150 Richmond Street Concept Plan Summary

I-195 Redevelopment District Commission Meeting
October 19, 2022

Concept Plan Submission

Site Utilities & Urban Design Priorities

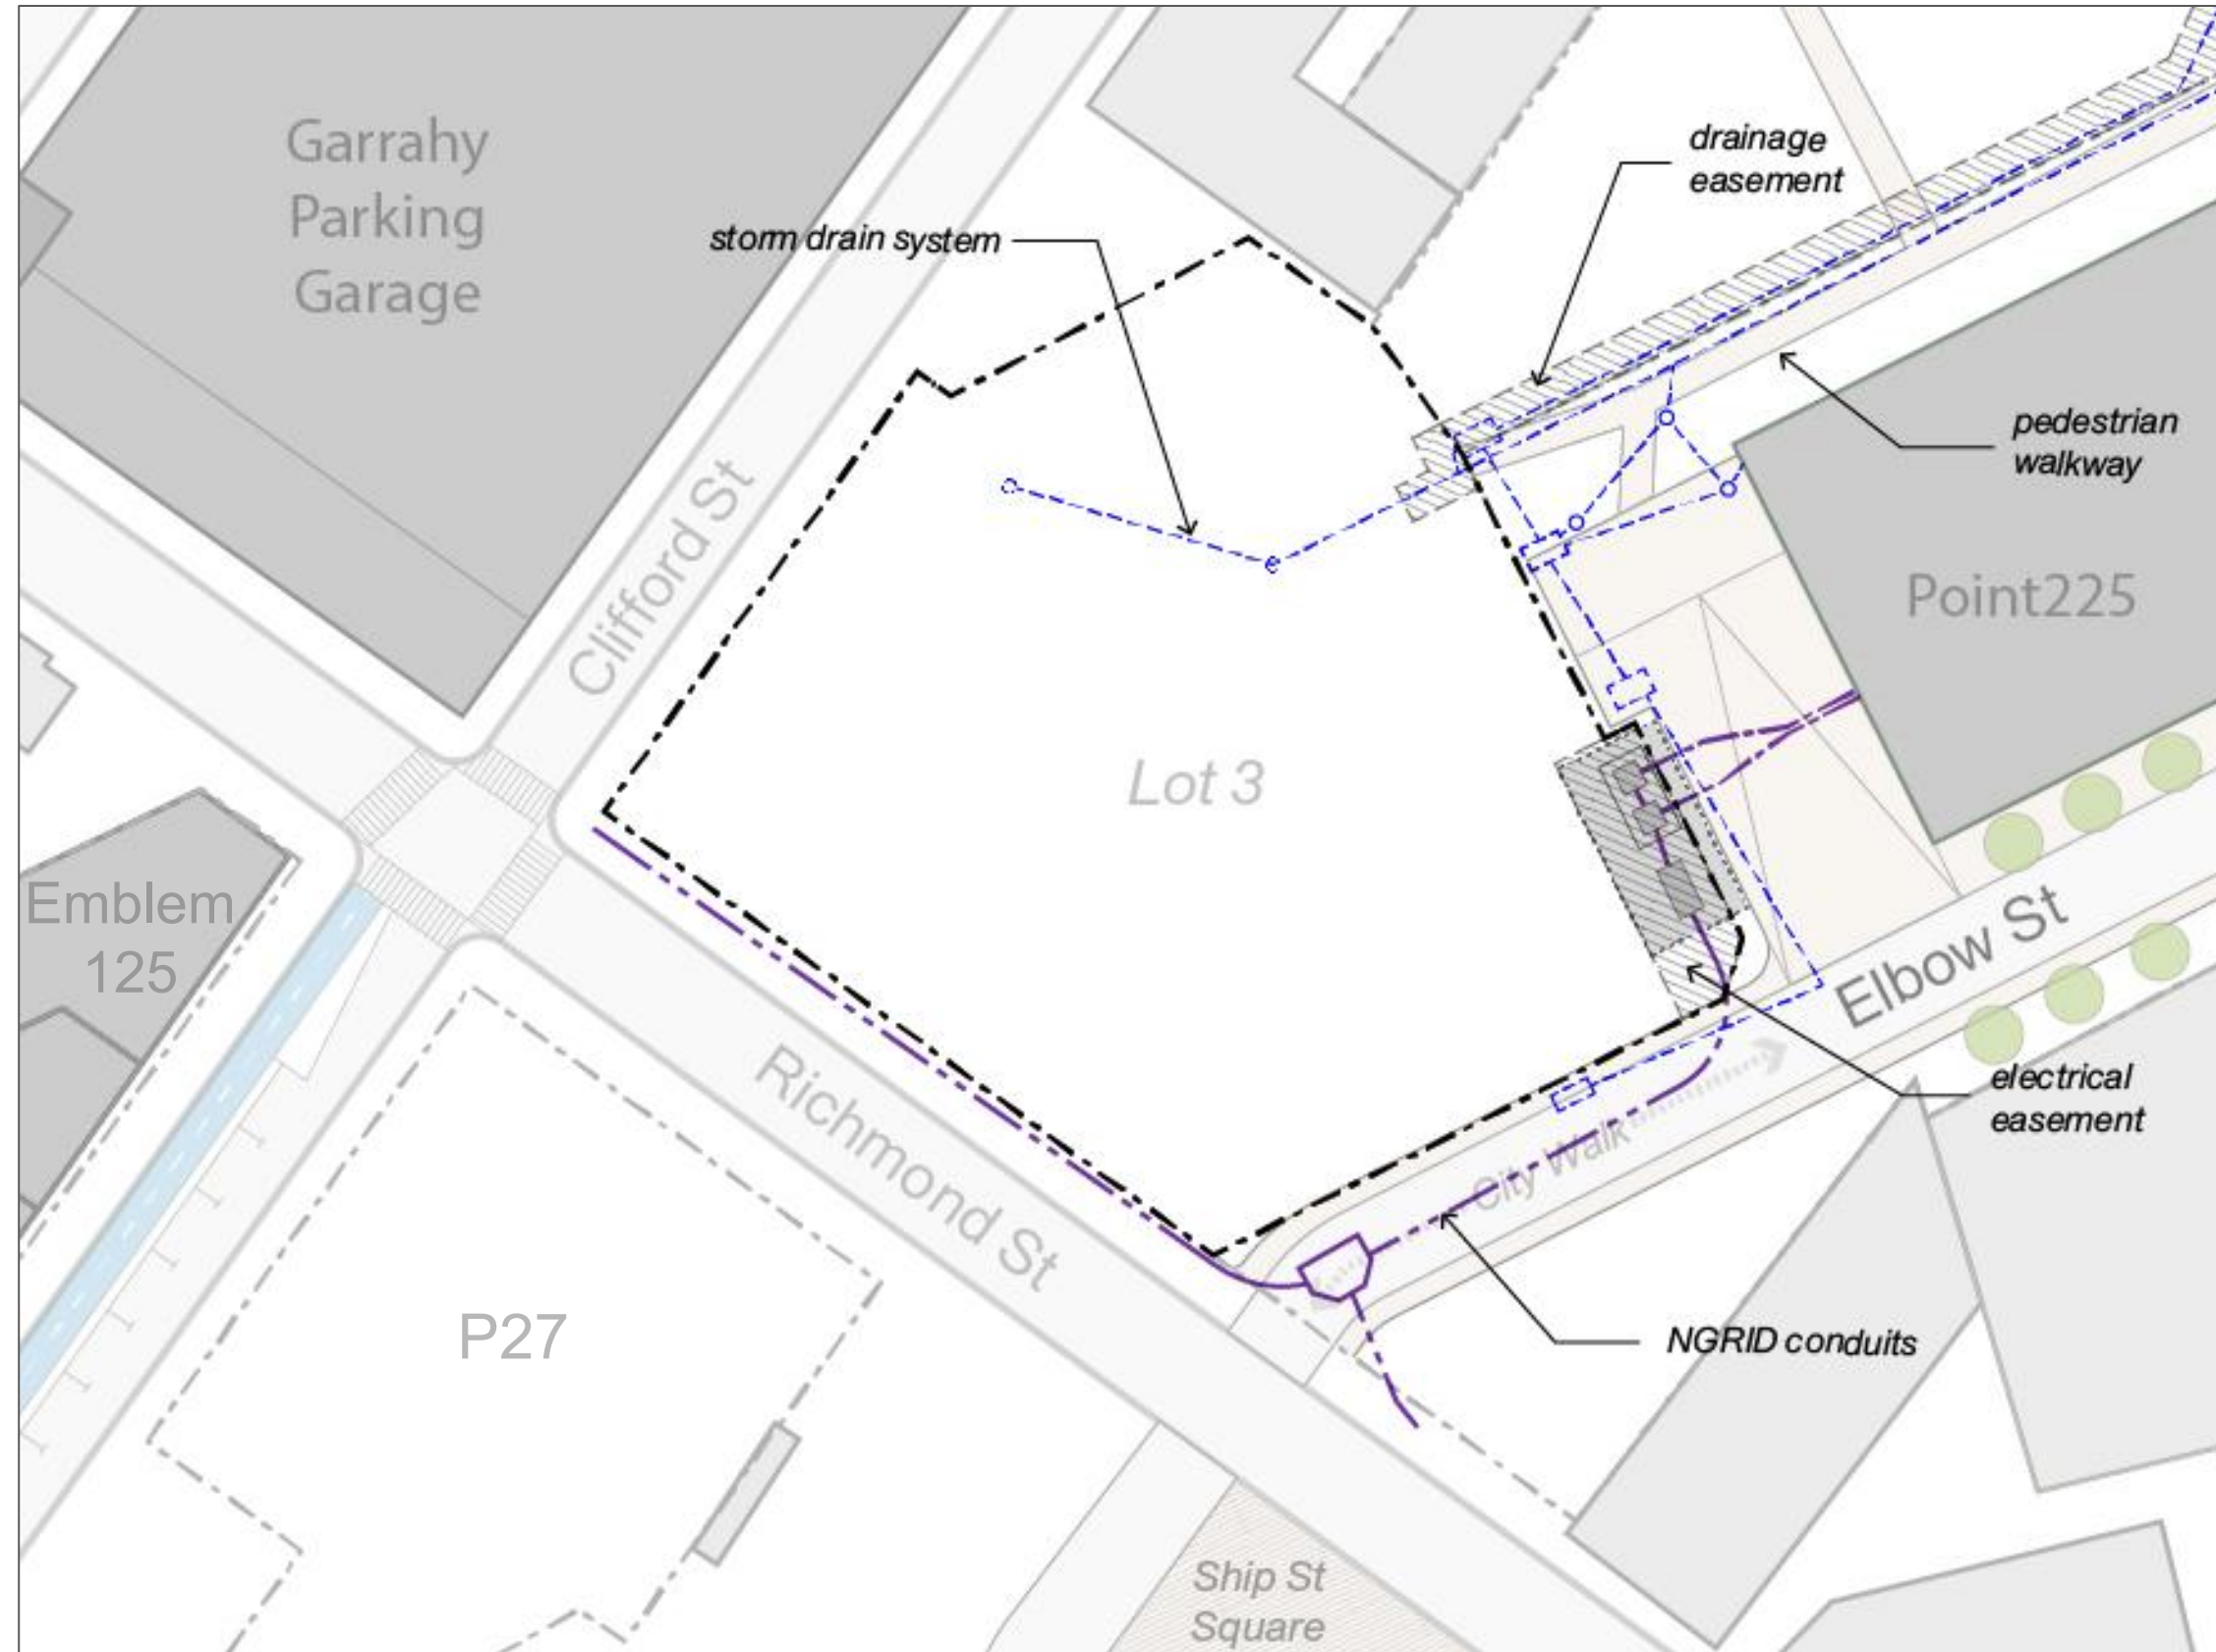
- Prioritize corner of Richmond Street and Elbow Street (CityWalk) for activation.
- Treat **Richmond Street** as a primary street and **Clifford Street** as a secondary street prioritized for truck circulation, service and loading.
- Screen all exterior at-grade MEP spaces from public view.
- Provide paved walkways to encircle the building for service access and continuity with the back-of-house pedestrian easement from the Wexford property.

Massing & Facade Composition

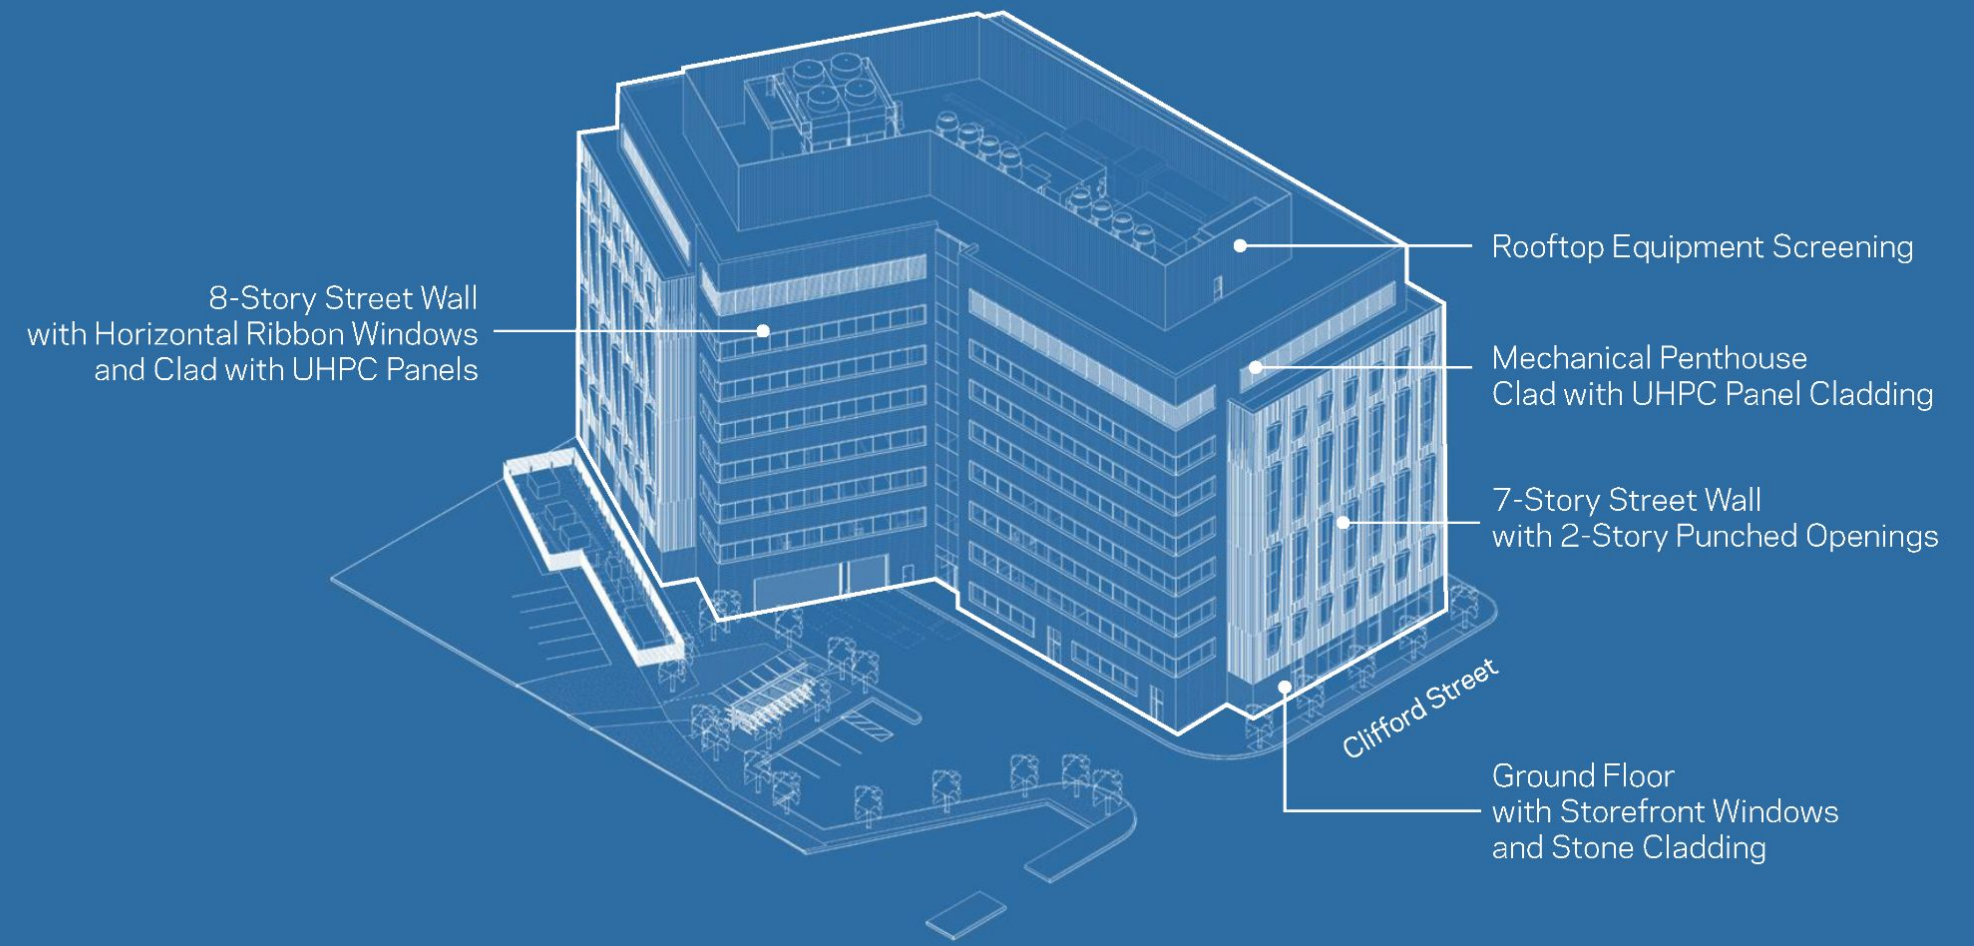
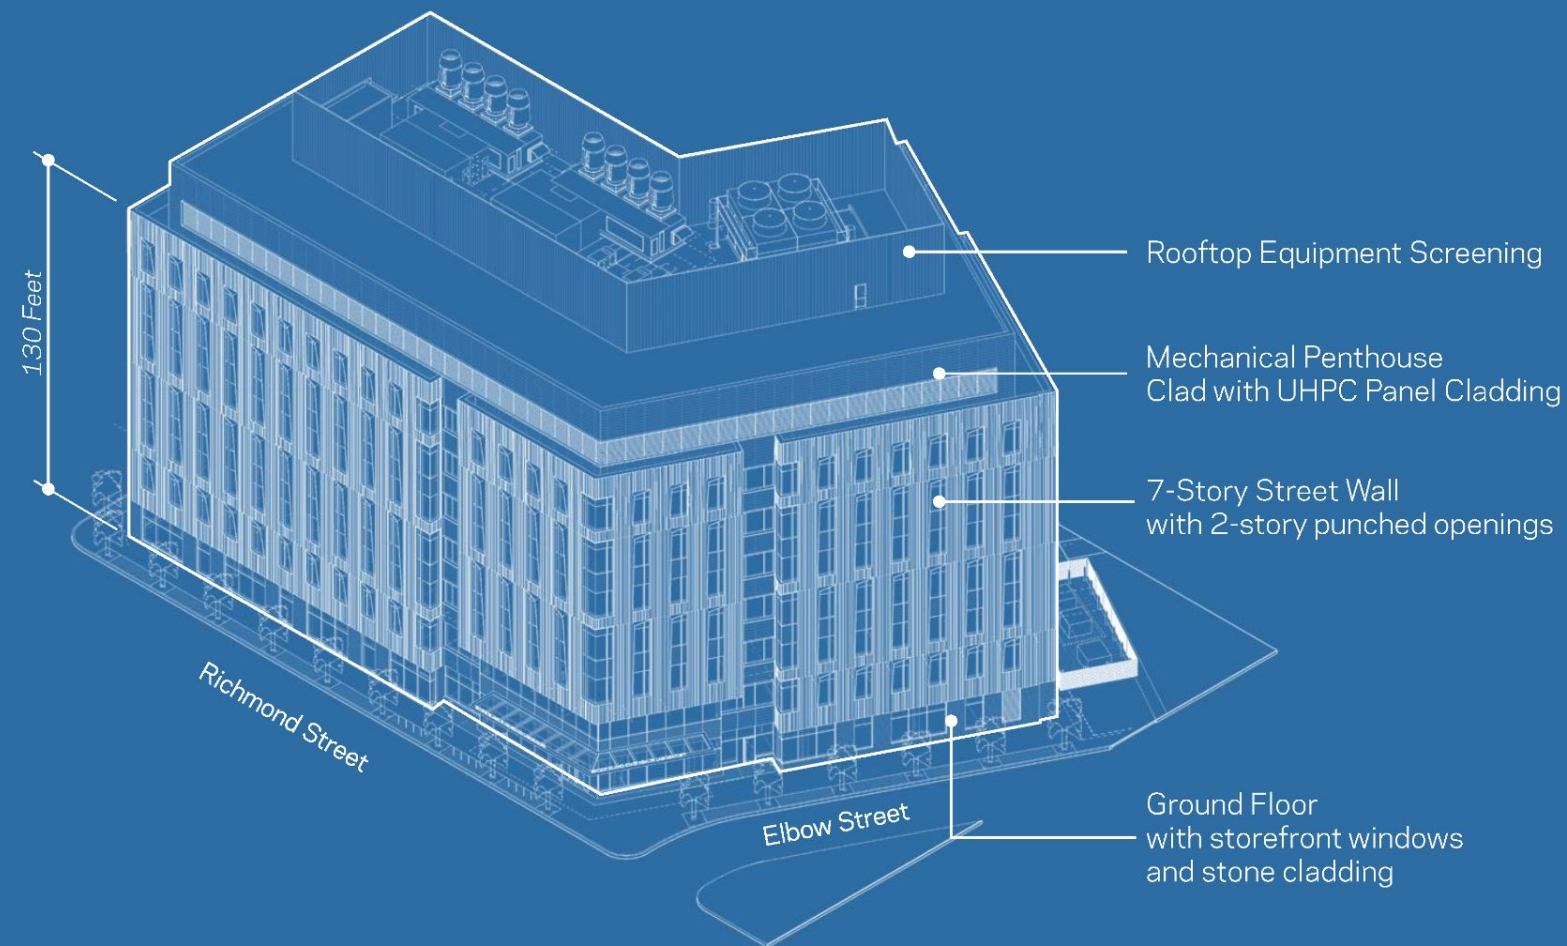
- Building creates strong streetwall on both Richmond and Elbow Streets.
- Progressive setbacks at upper levels helps reduce scale of building from street level view.
- Massing creates exterior expression of interior program configuration public vs. lab vs. office.
- While Richmond and Elbow Street facades will be the priority over the long-term, the rear building facade will in many ways be more visually prominent until nearby parcels are developed. Would like to see more attention to this facade to create visual interest and variety.

Ground Floor Activation

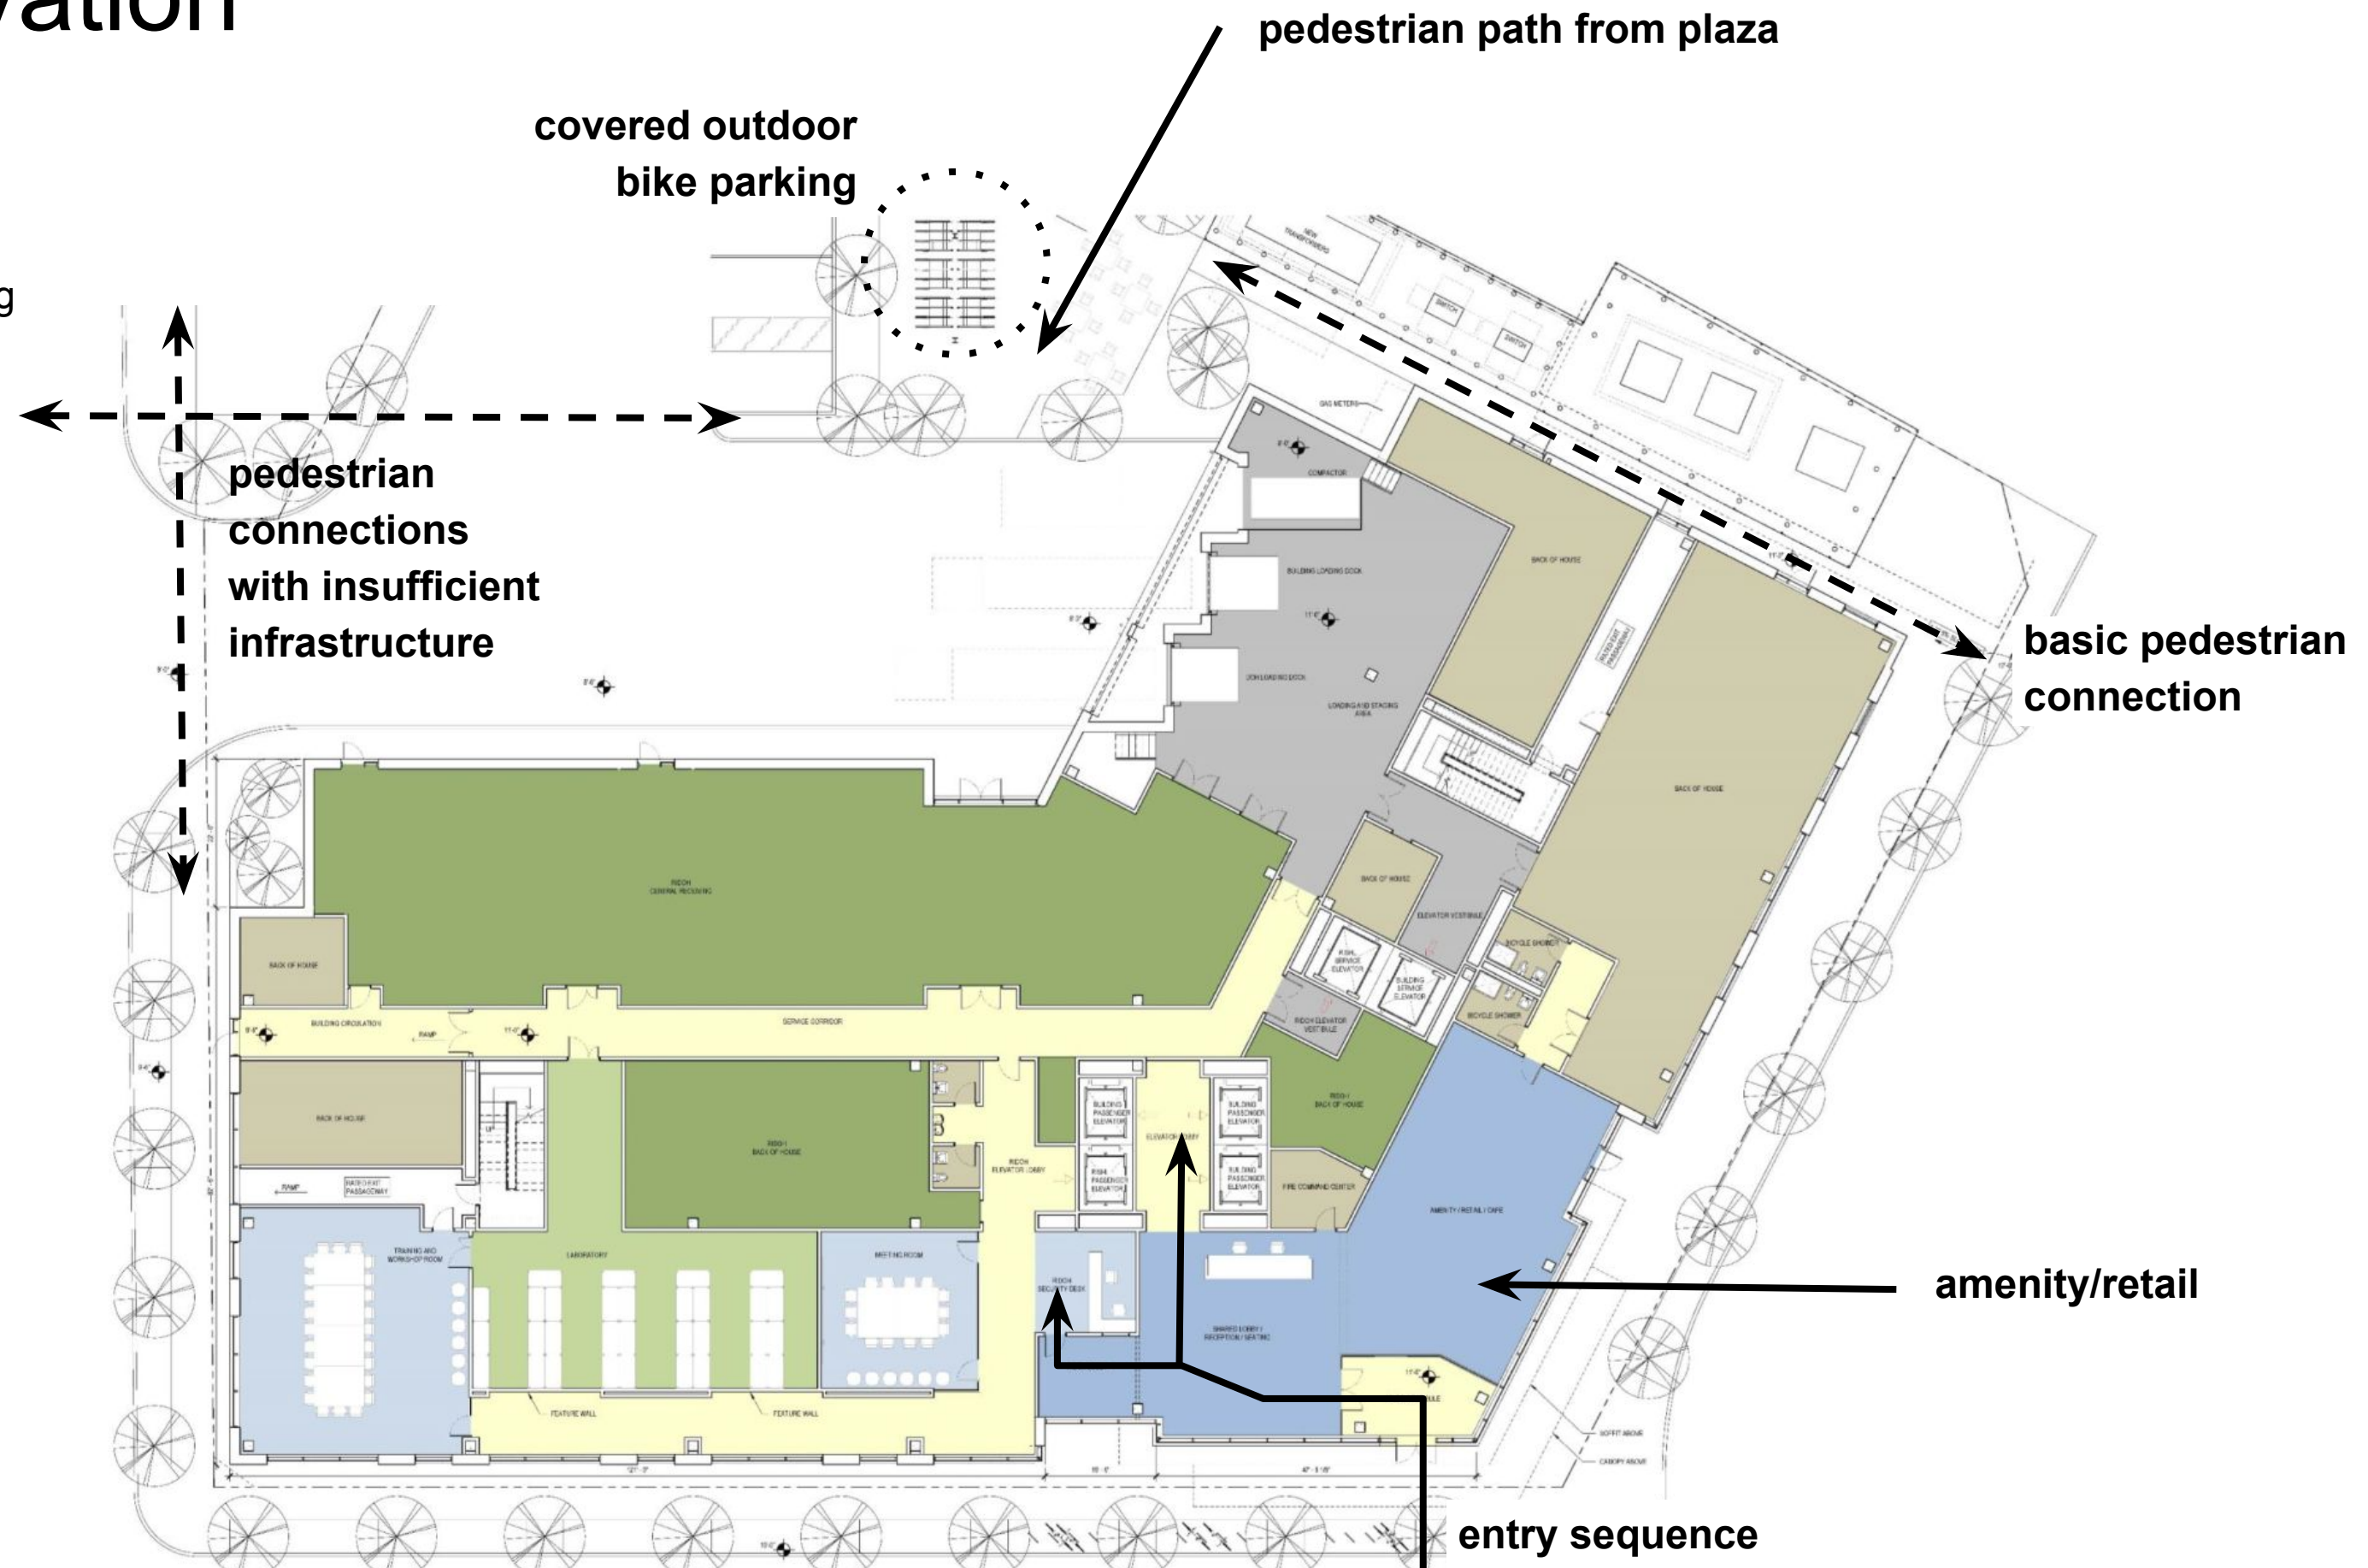
- Strategy to activate Richmond Street is effective - mix of lobby, hallway, and meeting space - suggest prioritizing high quality interior finishes in these spaces.
- Elbow Street frontage is mostly back-of-house. Suggest introducing interior bike parking to activate.
- Pedestrian circulation is not adequately prioritized in the site plan, especially in rear of building.
- Loading and surface parking solutions require further study - large curb cut and lack of adequate screening.
